**DATE:** May 23, 2023  
**TO:** All Prospective Bidders and Plan Holders  
**RE:** Vista Escondida Landscaping & Park Improvements City Project No. LL-04

### ADDENDUM NUMBER 1

STANDARD DRAWING ..
<b>W-8</b>
JUNE 2007

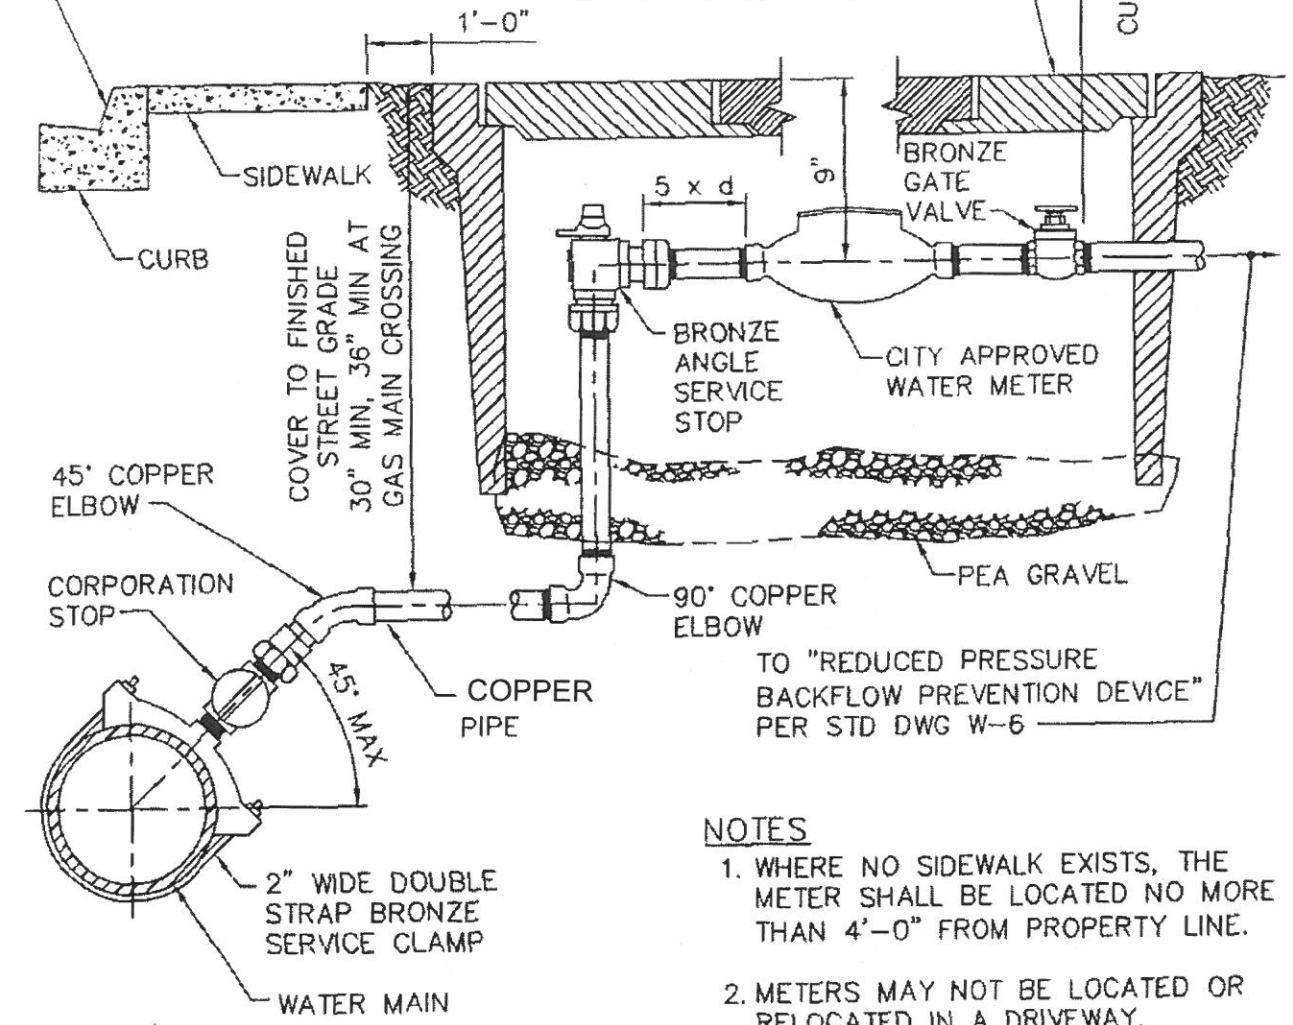
Trenching, bedding, backfilling and compacting shall be performed in accordance with Section 31 23 17 and the Standard Drawings. Provide a minimum cover of 36-inch below finished street grade. Contractor shall utilize copper Tubing in Lieu of Polyethylene pipe as shown in CWA Std. W-8.

**Hot Tap 1" Water Service** shall be paid for at the contract **Lineal Foot (LF)** basis as shown on the Bid Schedule. This item shall include furnishing all labor, equipment, tools and materials necessary to Furnish and Install 1" Water Service per the modified CWA Std. Dwg. W-8, and no additional compensation will be allowed. **Contractor shall utilize Copper Tubing in Lieu of Polyethylene Pipe as shown in modified CWA Std. W-8.** All Water Service and Meter Box installation and associated work shall be under direct CWA Inspection and shall be to the satisfaction of the City.
